University Avenue

Response from Iowa DOT to Questions and Comments from City Council Meetings, December 17 & 18, 2012

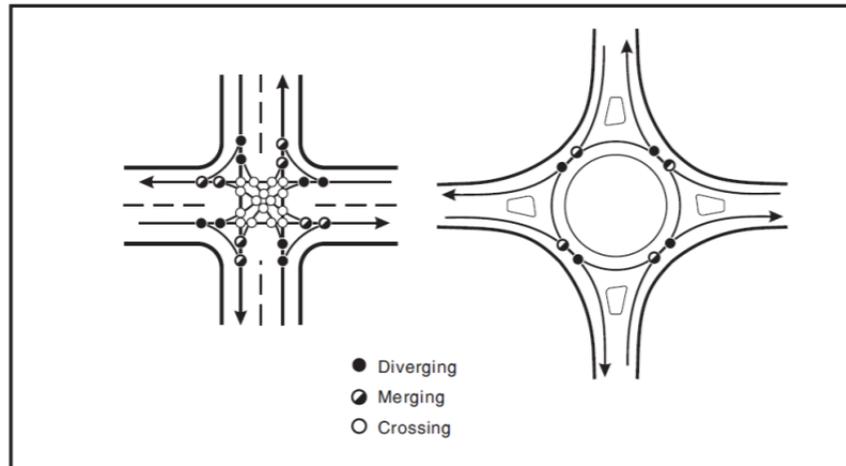
4. What are some of the benefits and drawbacks of Roundabouts?

Roundabouts offer safety benefits as well. The reduced speeds and conflicts at roundabouts help to reduce the number of overall crashes. The elimination of conflict points and higher-risk conflicts (such as left-turns against through traffic resulting in broadside collisions) help reduce the severity of crashes. These factors contribute to significantly reducing the number of injury crashes at roundabout intersections versus other types of intersections. As noted by the FHWA², "The most comprehensive and recent study showed overall reductions of 35 percent in total crashes and 76 percent in injury crashes."³ These results are described in greater detail in the NCHRP Report 572, "Roundabouts in the United States", available at http://onlinepubs.trb.org/onlinepubs/nchrp/nchrp_rpt_572.pdf. We are in the process of evaluating the corridor changes based on the Highway Safety Manual and the Texas Transportation Institute safety criteria evaluation methods to quantify potential safety performance of each alternative.

The diagram below (Exhibit 5-2 from the FHWA *Roundabouts: An Informational Guide*⁴) shows the difference in vehicular conflict points for a four-leg intersection with single-lane approaches. Conflict points are reduced from 32 to 8 at a roundabout intersection for the same location.

Proposed typical section for both Alternative 2 and Alternative 4, with on-street bike lanes

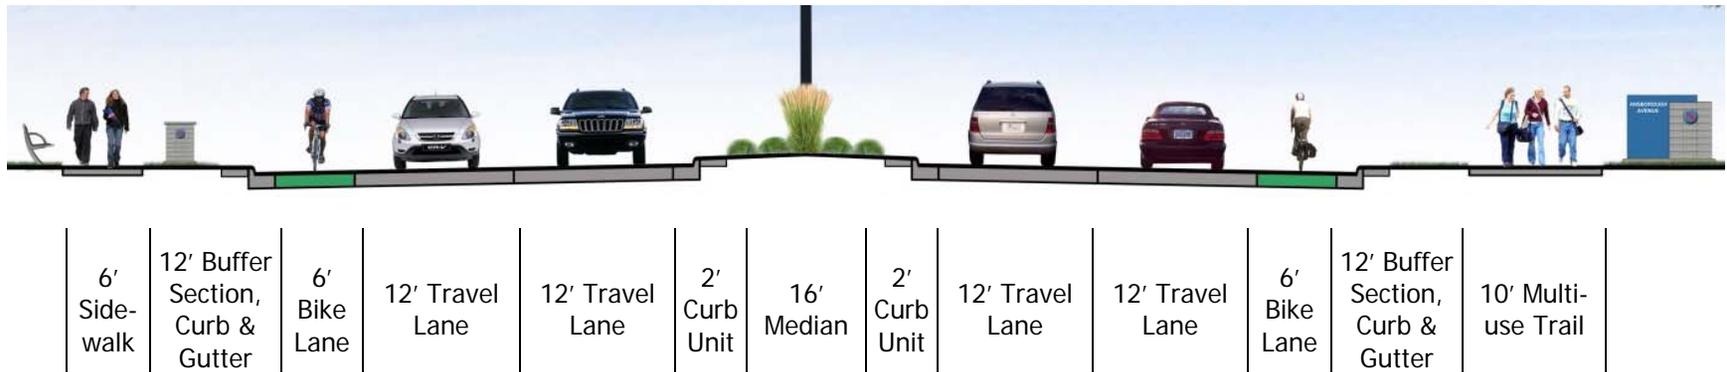
8. How do bicycles and pedestrians navigate the intersections?

Traffic-optimized signal: The basic cross-section (see last page) has 84 feet of crossing distance. At intersections with a right turn lane, this distance could increase. For bicycles and pedestrians on the sidewalk or bike trail, the pedestrian signals (WALK/DON'T WALK) provide assistance in crossing. In locations without a left turn lane, a pedestrian refuge could be placed in the median. At most locations, the on-street bike lanes will be located between the through and right turning lanes (where provided) to allow for through bikes to continue with the through signal. Non-motorists using either the on-street bike lanes or off-street trail and sidewalk will still need to be aware of conflicts with turning traffic.

Roundabouts: Bike lanes are transitioned to the sidewalk ahead of the roundabout, so the basic cross-section has 72 feet of crossing distance. Bicycles and pedestrians on the sidewalk or bike trail can cross an approach in two stages; the splitter island on each approach provides a refuge area to wait if necessary. Although there is no stop signal for traffic, roundabouts provide for slower speeds than traffic signals. Additionally, the placement of the sidewalk means that drivers have completed the intersection maneuver and thus can focus their attention on the pedestrian crossing (see the diagrams above for Question 4). A high volume of pedestrian traffic may support the placement of pedestrian beacons to aid in crossing. The on-street bike lanes transition out at a roundabout in advance of the intersection. The user may either exit to the sidewalk via a small ramp to the sidewalk/multiuse path or may merge with the traffic lane to enter the roundabout as a vehicle. The merge occurs at a location where motor vehicle and bicycle speeds are similar. For more information on bicycle and pedestrian safety at roundabouts, see NCHRP 264, *Modern Roundabout Practice in the United States*⁸, Chapter 8, "Issues Related to Pedestrians, Bicyclists, and the Visually Impaired", available at:

This cross section is an example of a typical section with dimensions based on Iowa DOT design standards. The Iowa DOT Office of Design Manual is available online at <http://www.iowadot.gov/design/dmanual/manual.html>; design criteria are discussed in Chapter 1C-1. Adjustments would be made at intersection approaches for turn lanes, and at bus stop and driveway locations. Adjustments may also be made to minimize right-of-way needs or impacts to adjacent businesses and access points. For example, the widths of the median, curb and gutter, buffer sections, and lane widths could be adjusted to reduce the total cross section width. These changes can have other effects and would need to be investigated further.
